MIL-C-17587B(SH)
AMENDMENT 1
1 July 1986

MILITARY SPECIFICATION

CIRCUIT BREAKERS, LOW VOLTAGE, ELECTRIC POWER, AIR,
OPEN FRAME, REMOVABLE CONSTRUCTION

This amendment forms a part of MIL-C-17587B(SH), dated 18 April 1983, and is approved for use by the Naval Sea Systems Command, Department of the Navy, and is available for use by all Departments and Agencies of the Department of Defense.

FIGURE 13. Time-current characteristics curve for circuit breaker types ACB-2000LR, ACB-2002HR and ACB-6400HR.

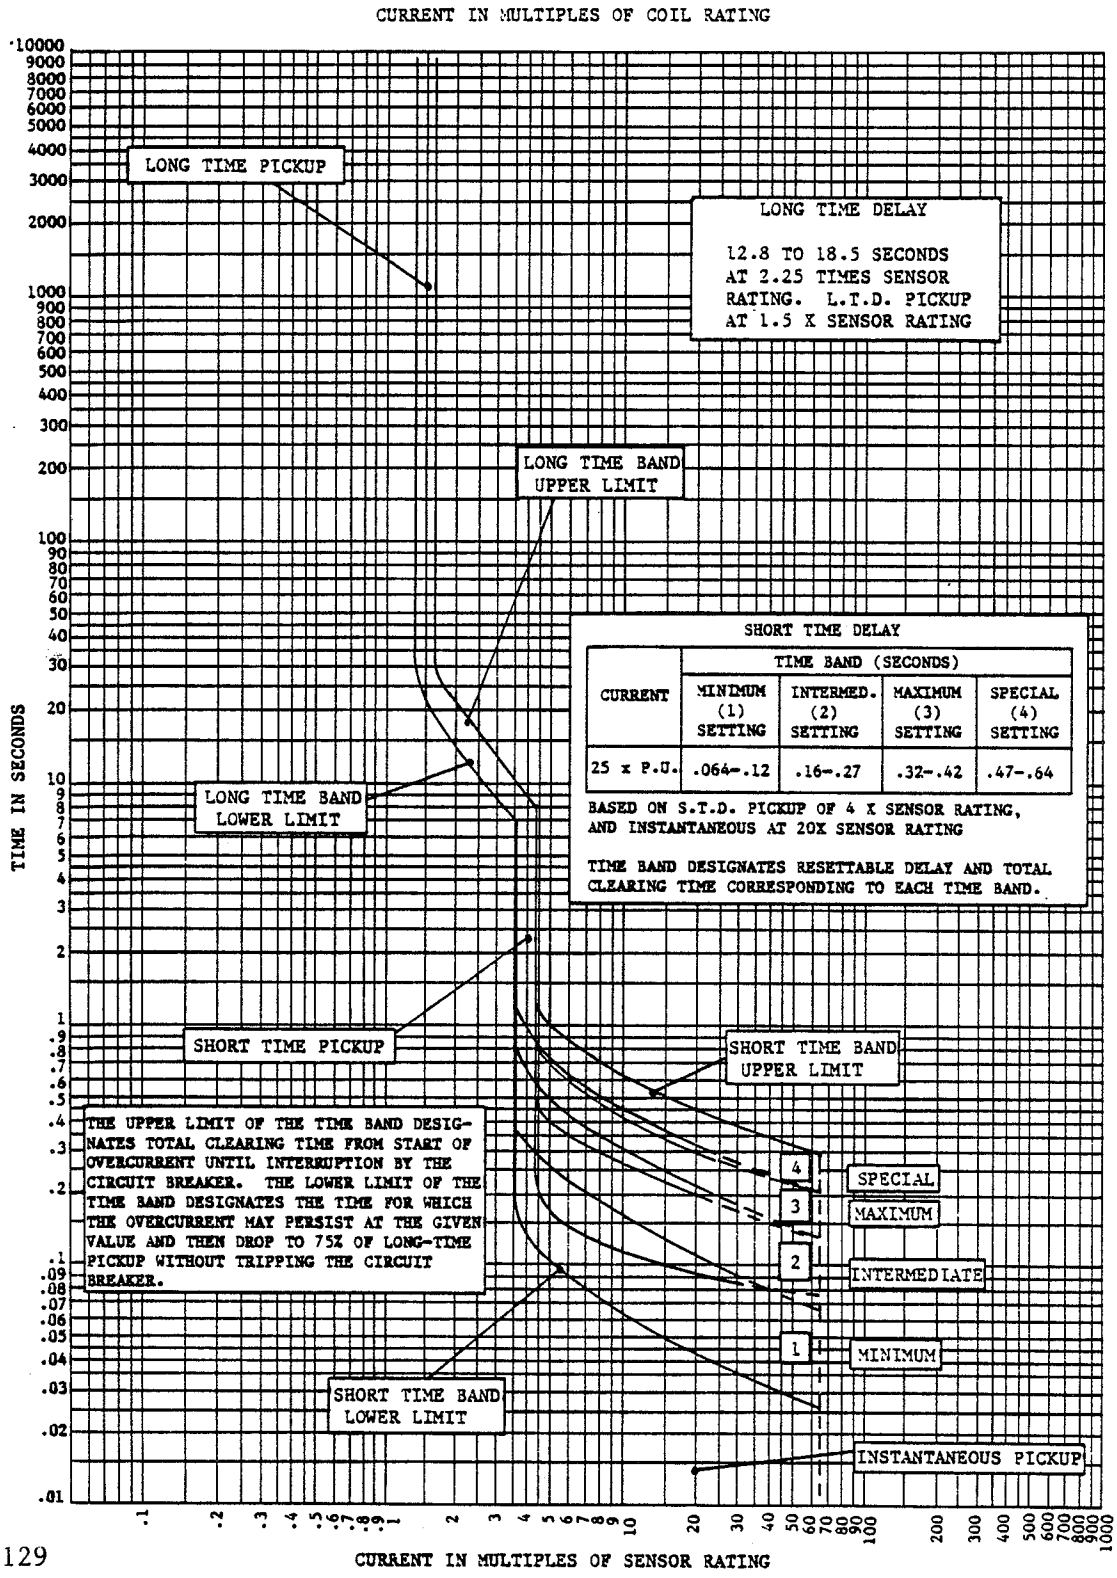
Figure 13: Delete and substitute:
